CITY of NOVI CITY COUNCIL

Agenda Item D
March 24, 2014

SUBJECT: Approval of a request from IAC Novi, LLC, applicant for the Berkshire Pointe development, for a variance from Section 11-68(a)(1) of the Design and Construction Standards requiring water main extensions longer than 800 feet to include a secondary connection point to the water distribution network (868 feet proposed).

Re: Berkshire Pointe – Water Main Stub
Variance from Design and Construction Standards

OVERALL UTILITY PLAN
BERKSHIRE POINT
 NOVI, MICHIGAN, SECTION 18

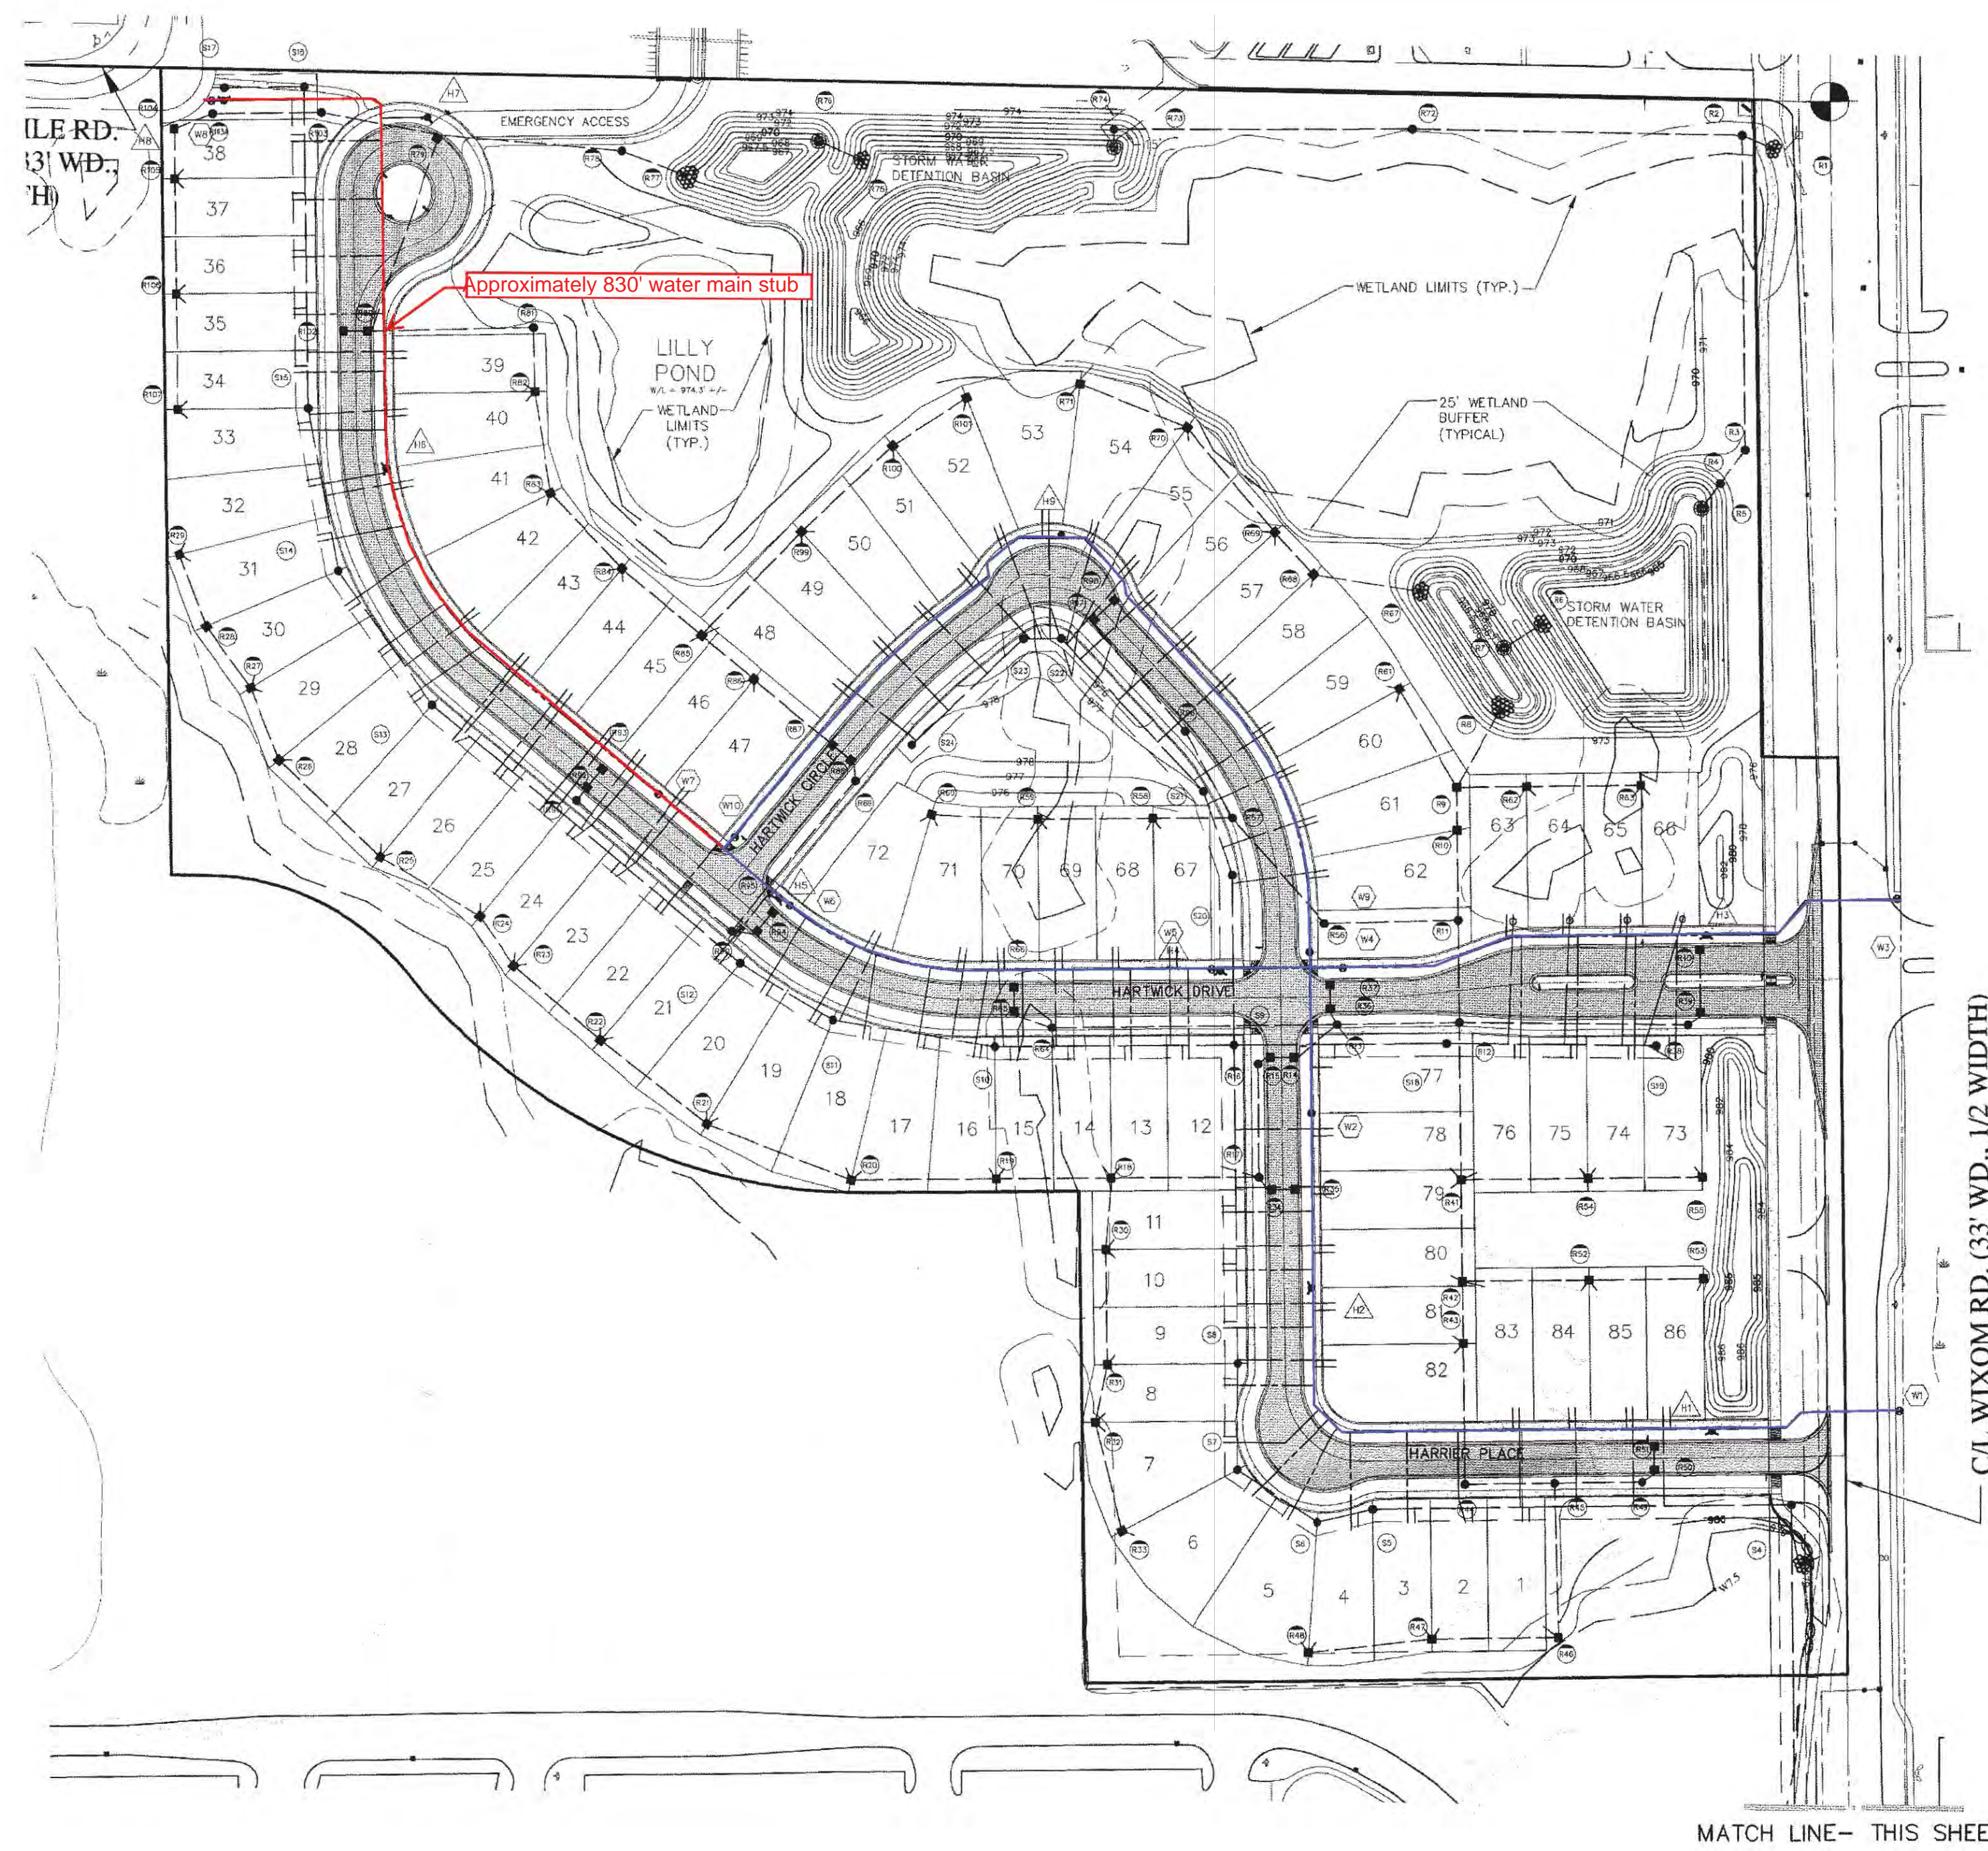
Berkshire Pointe is a proposed 86 unit single family condominium on approximately 29.15 acres located west of Wixom Road near Grand River Avenue. The applicant, IAC Novi, LLC, has submitted a final site plan and is requesting a variance from the Chapter 11 of the Novi Code of Ordinances, commonly known as the Design and Construction Standards (DCS). The applicant has provided two points of connection for the proposed water main off of the existing 16-inch water main on Wixom Road to serve the development. The applicant has also proposed a 12-inch water main stub to be provided at the northwest corner of the property adjacent to 12 Mile Road for future extension per the requirements in the DCS, but the 12-inch extension is 868 feet long and exceeds the maximum allowable water main stub length of 800 feet in the DCS.

The applicant has designed the water main to accommodate a future extension along 12 Mile Road to provide a looped system. The applicant has provided a water system model for the development which was calibrated to a hydrant test on Wixom Road. The applicant's model demonstrates that 2,140 gallons per minute would be available at 12 Mile Road. The modeled flow exceeds the DCS minimum of at least 2,000 gallons per minute for fire protection in a single family residential subdivision.

variance request, the applicant has demonstrated that in this specific case the specifications in the DCS would result in exceptional difficulty, and that the proposed design is adequate for the intended use without creating a circumstance that would be detrimental to public health and safety. For these reasons, staff recommends approval of the requested variance from Section 11-68(a)(1) of the Design and Construction Standards, because the applicant's submittal indicates comparable performance to the Ordinance standard.

**WATER MODEL PLAN
 BERKSHIRE POINTE**
 NOVI, MICHIGAN

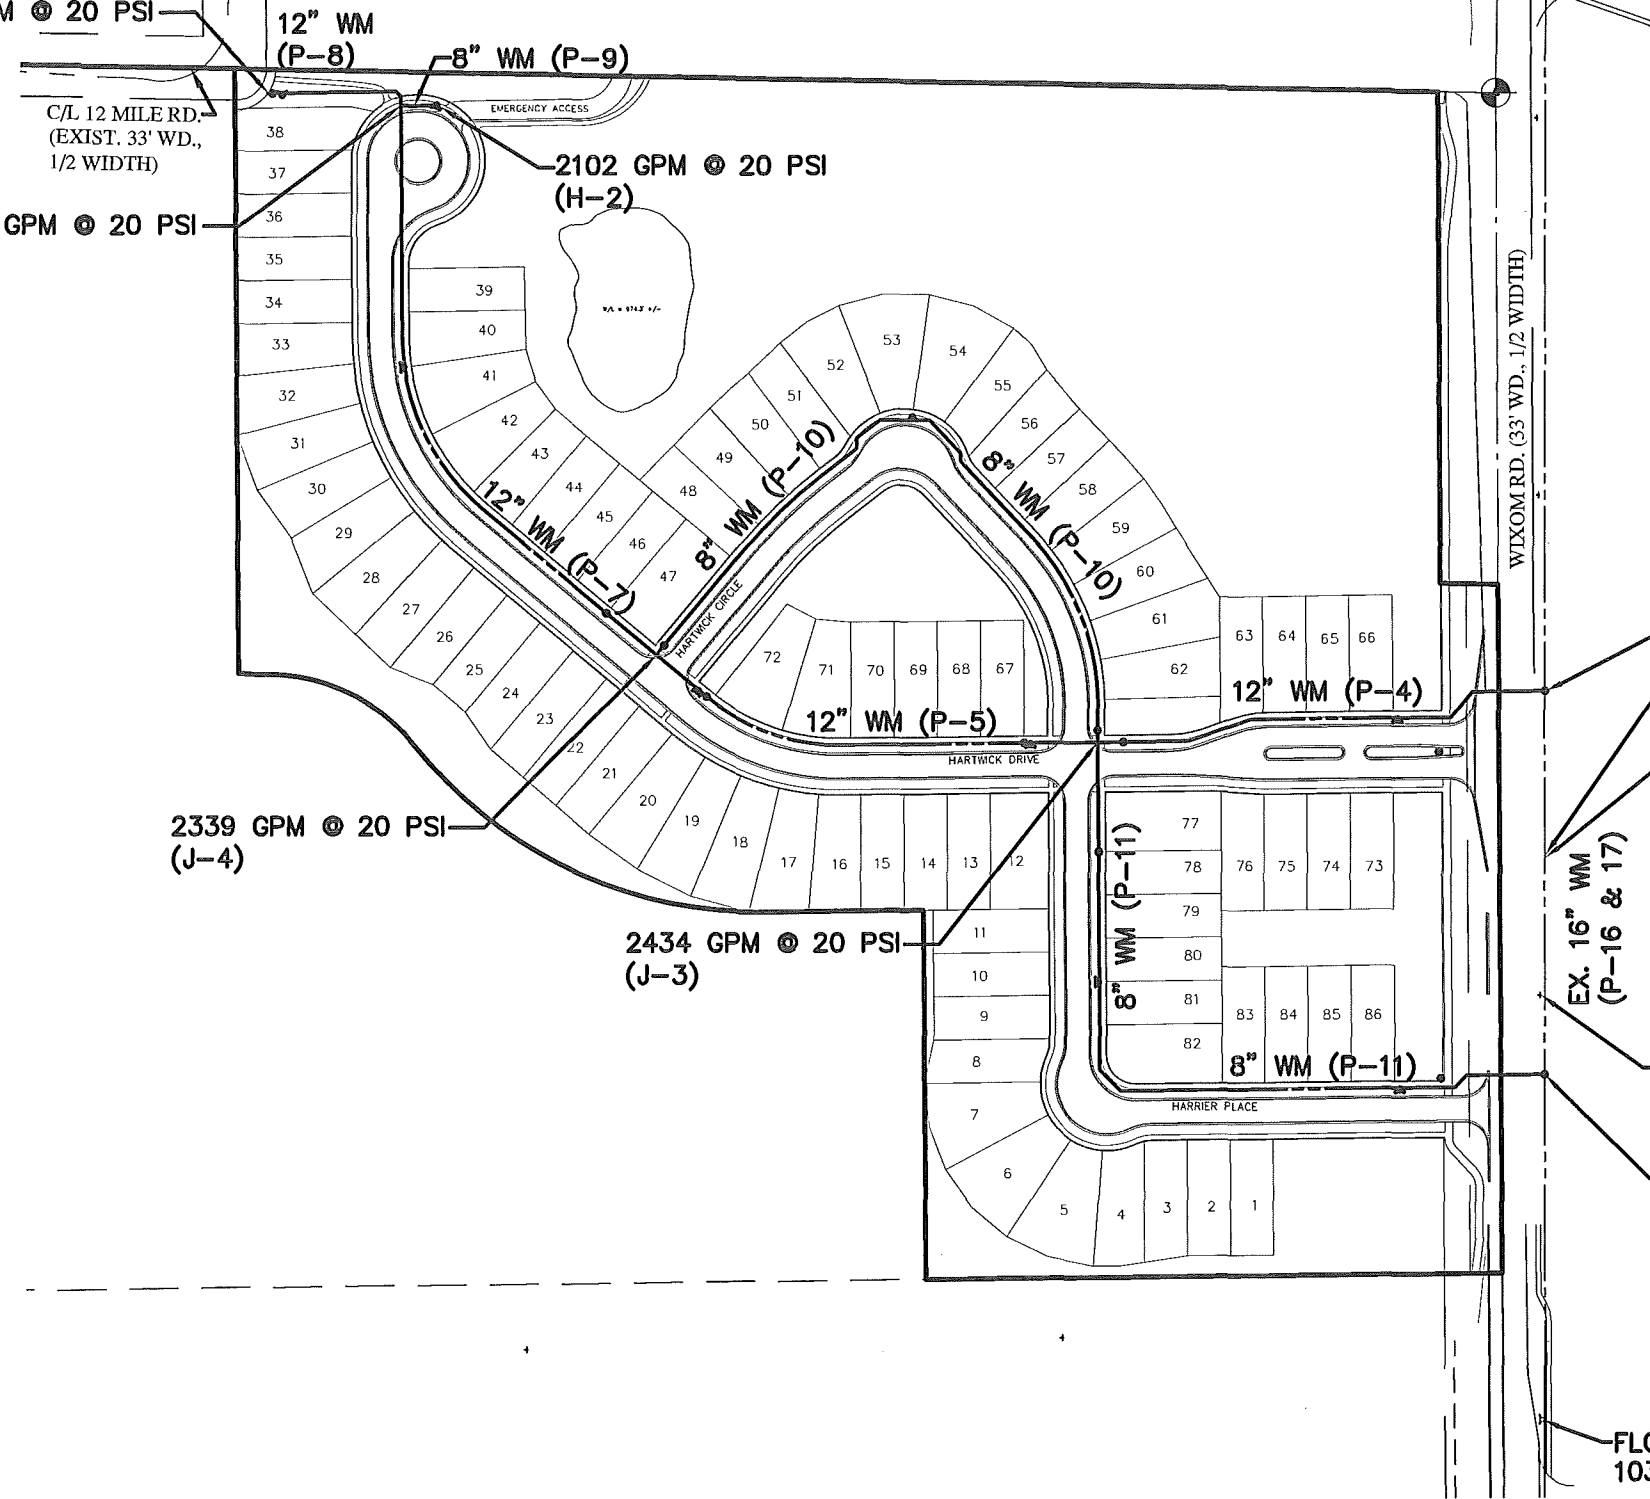
The fire flow model results shows that at the proposed 12" stub near 12 Mile Road, a flow of 2140 gpm at 20 psi can be provided (see attached "Fire Flow Report"). This exceeds the City's minimum requirements.
